# NOTICE OF DECISION

### CLASS 3 SITE PLAN REVIEW/ CLASS 2 ADJUSTMENT / CLASS 2 DRIVEWAY APPROACH PERMIT CASE NO.: SPR-ADJ-DAP22-35

**NOTICE OF DECISION DATE:** September 22, 2022

**REQUEST:** An application for development of two new restaurant buildings within the Willamette Town Center.

# SITE PLAN

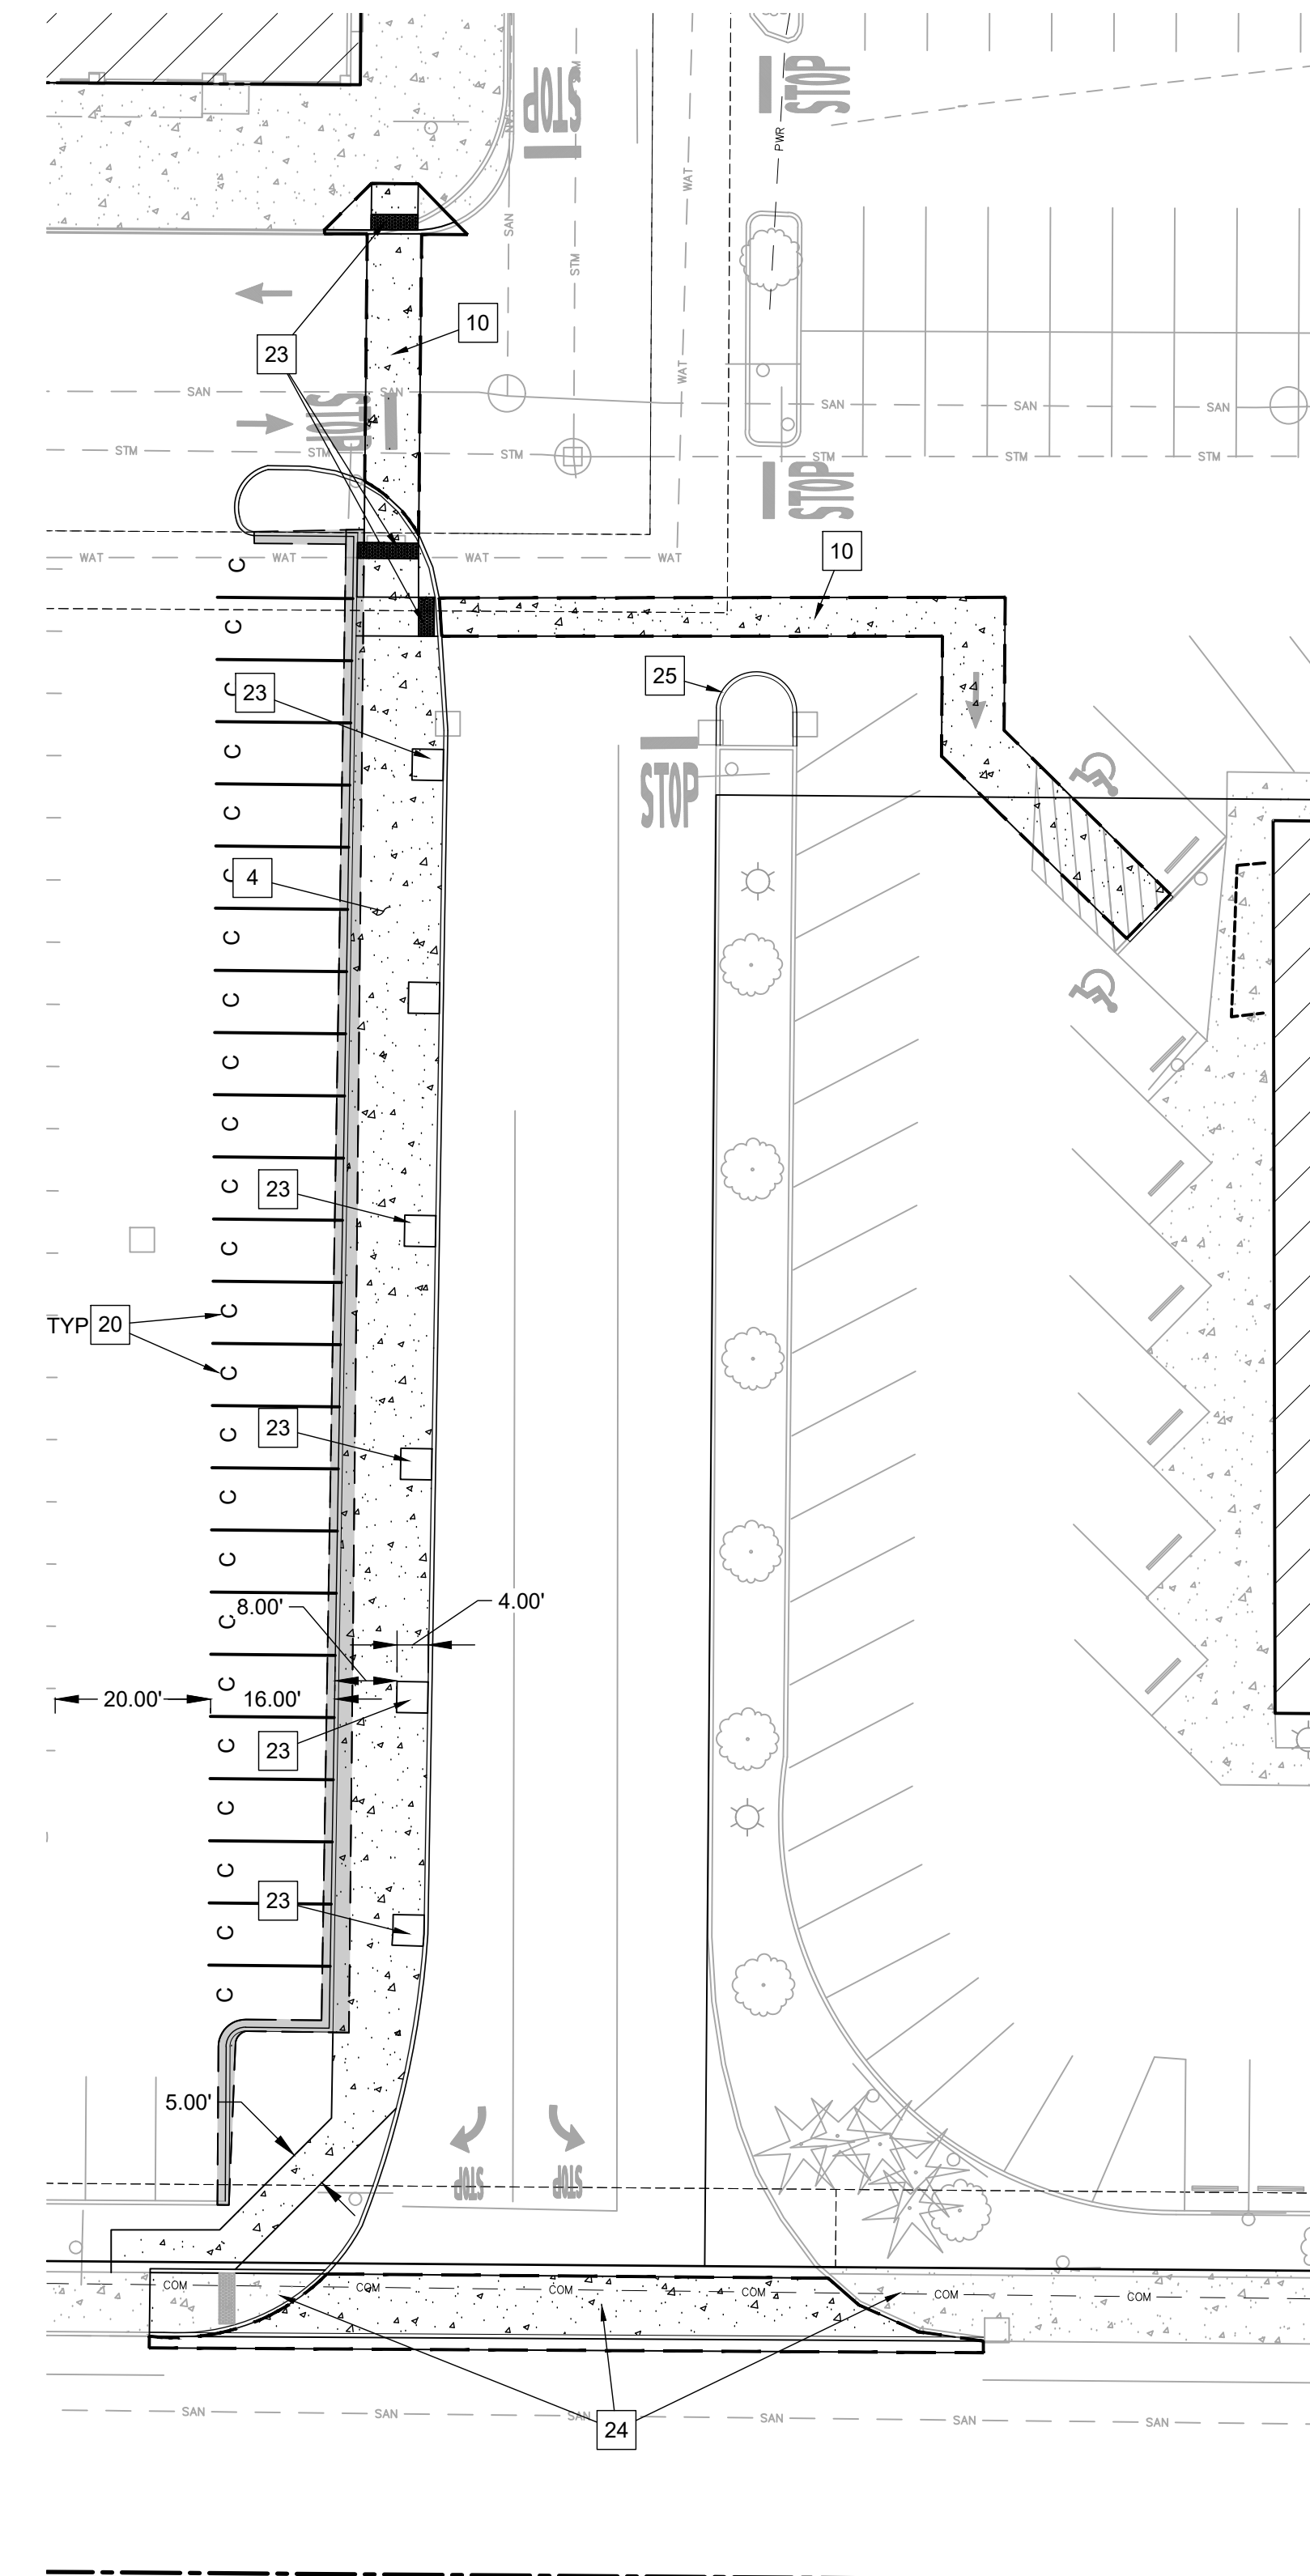
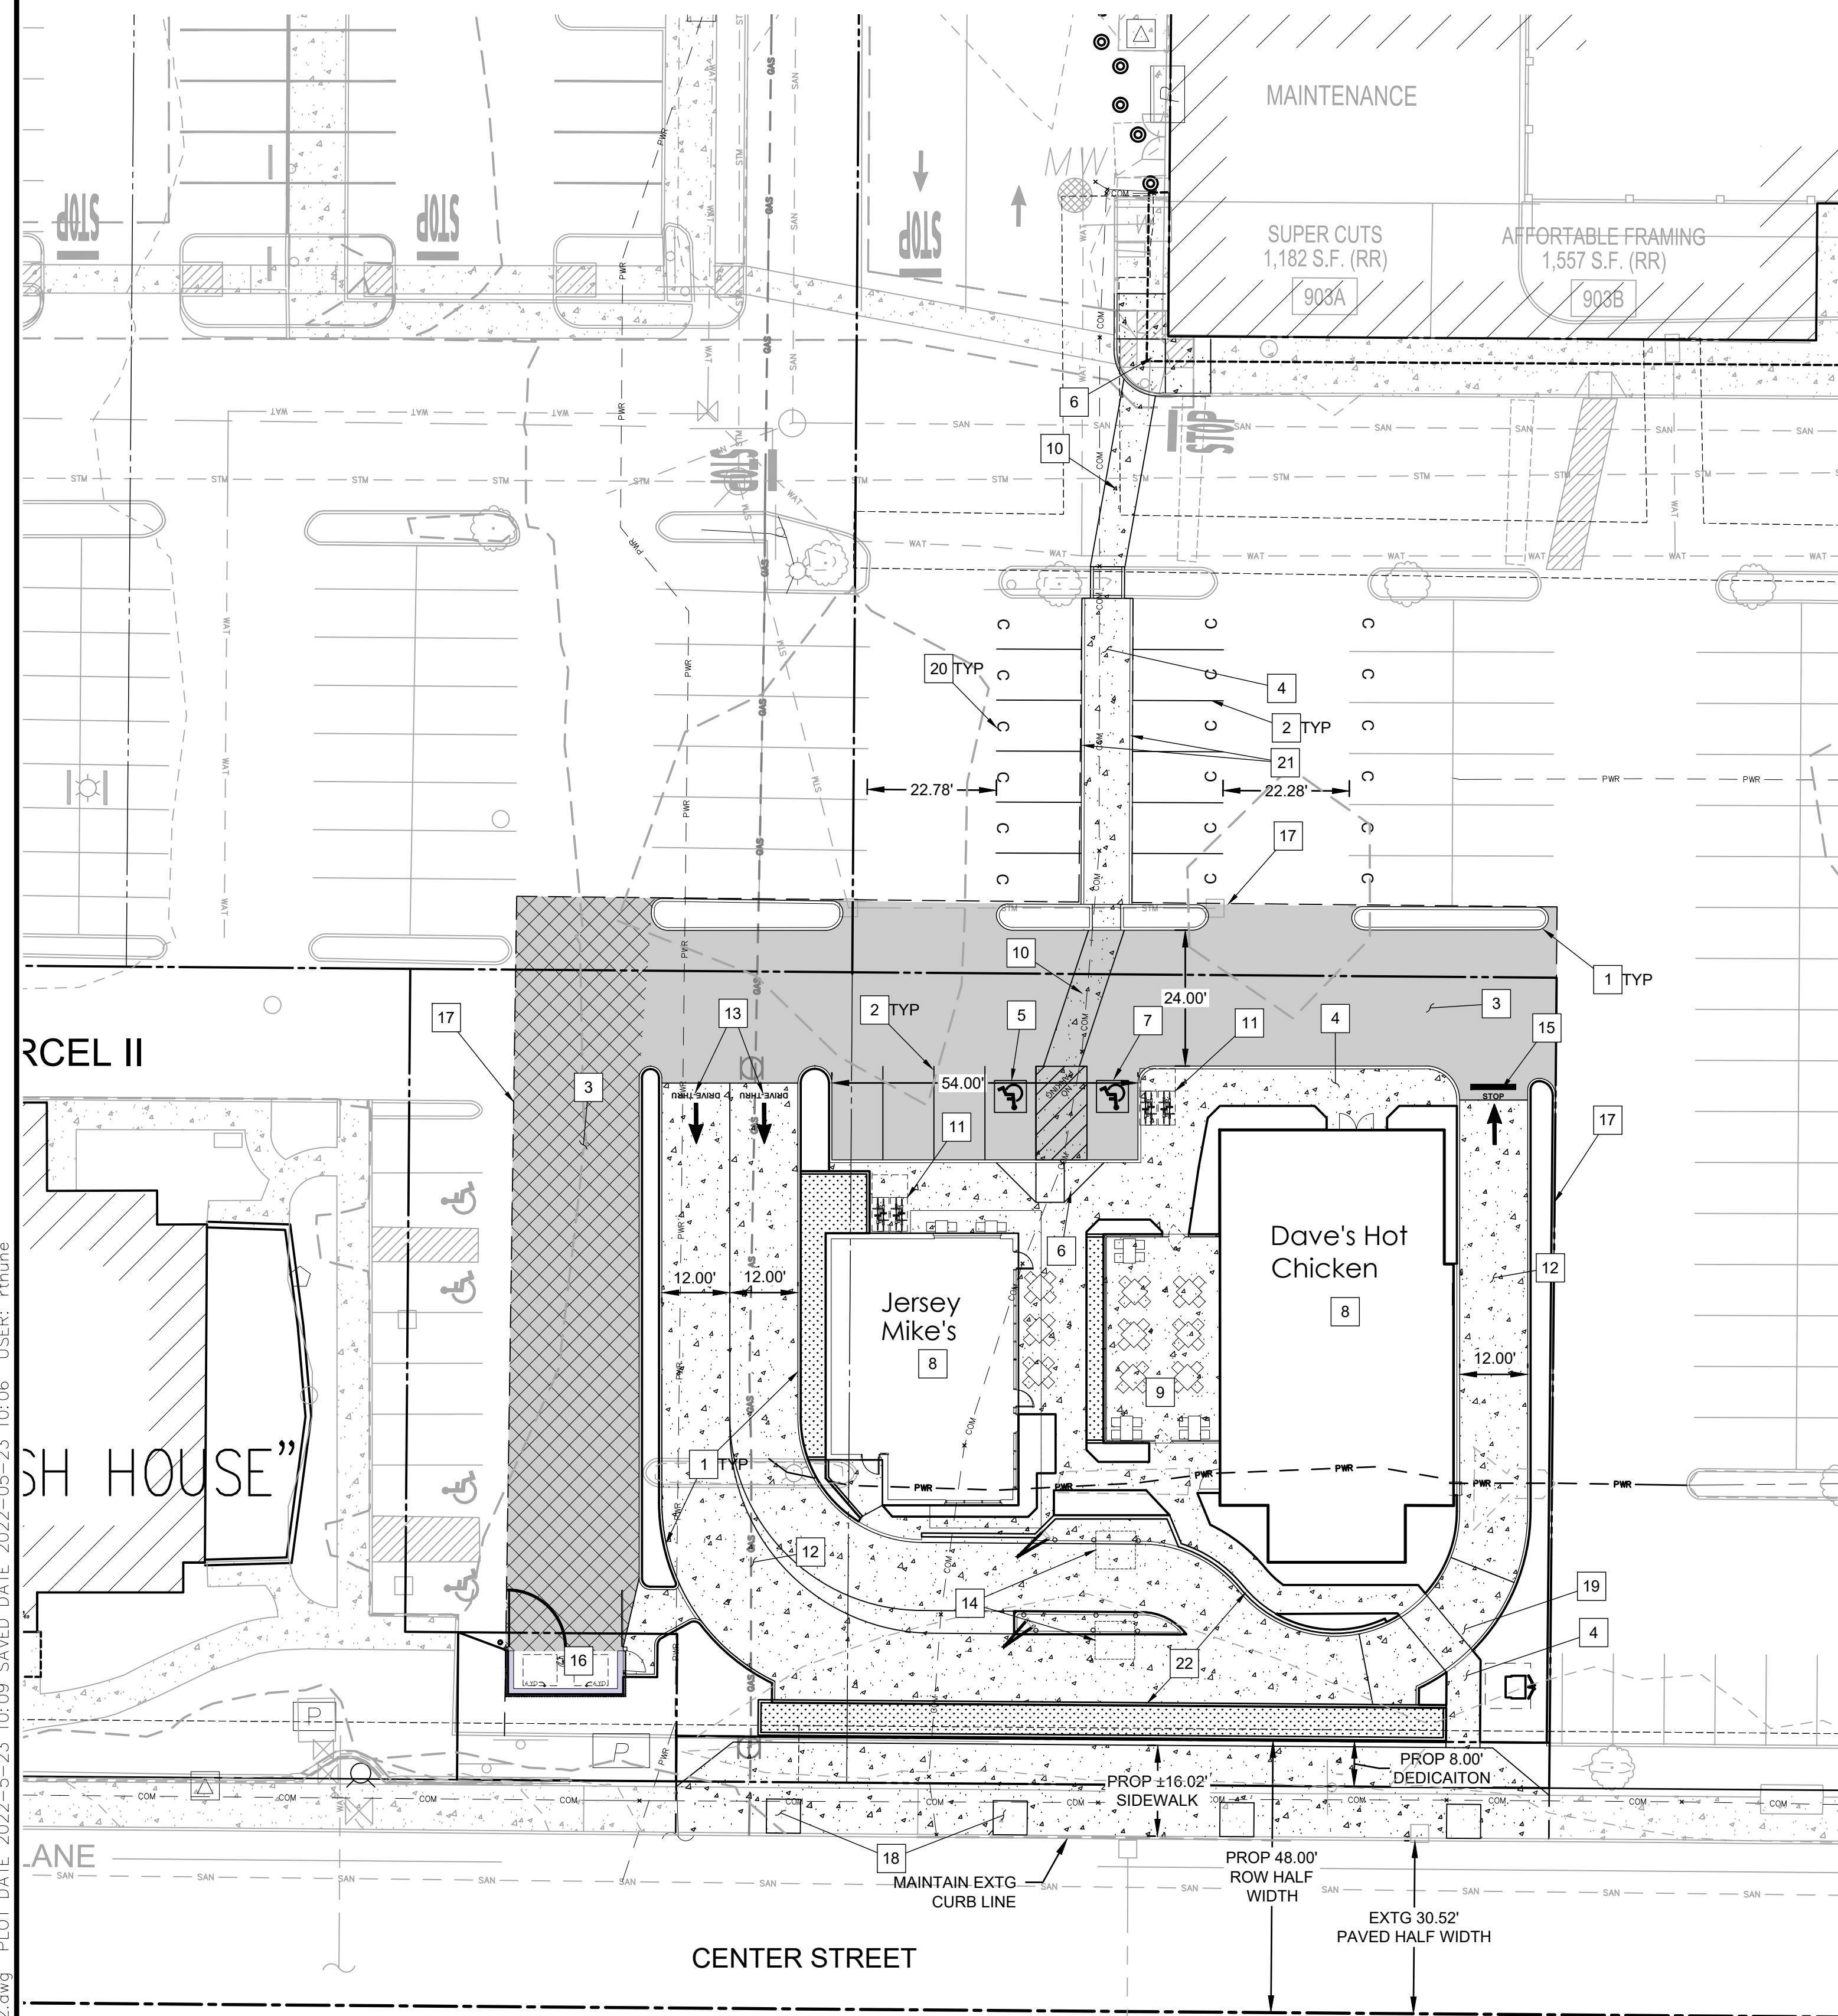
**Finding:** The proposed plans do not indicate the pad area surrounding the trash enclosures. To ensure compliance, the following condition applies:

**Finding:** Center Street NE is a transit route with two stops on the south side of the mall development site. The existing and proposed pedestrian connections are not located within 20 feet of these transit stops. The applicant previously received an adjustment to eliminate the requirement to provide a pedestrian connection within 20 feet of a transit stop (SPR-ADJ20-20), which was also included under SPR-ADJ-DAP20-26 and has been requested again as this part of the proposed development has not changed. Findings for the Adjustment are included in Section 7 of this report.

**Finding:** The proposed modifications of the parking lot meet setbacks, except an interior property line crosses the existing parking and vehicle use area west of the area that will be modified, and there are no setbacks proposed on either side of the property line. The applicant has requested an adjustment to the setbacks abutting the interior property line. Findings for the adjustment are in Section 7 of this decision.

**Finding:** The applicant's site plan indicates four proposed bike parking spaces on the north side of the west building and four proposed bike parking spaces on the north side of the east building, both of which are within a convenient distance of their respective building entrances. This standard is met.

**Finding:** The driveway access onto Center Street NE provides for safe turning movements into and out of the property. Plans show the existing driveway approach along Center Street NE will be modified to meet Commercial driveway approach standards pursuant to PWDS.

**Condition 3:** At the time of building permit, the applicant shall indicate the surrounding pad area for the trash enclosure, pursuant to SRC 800.055(b)(1).
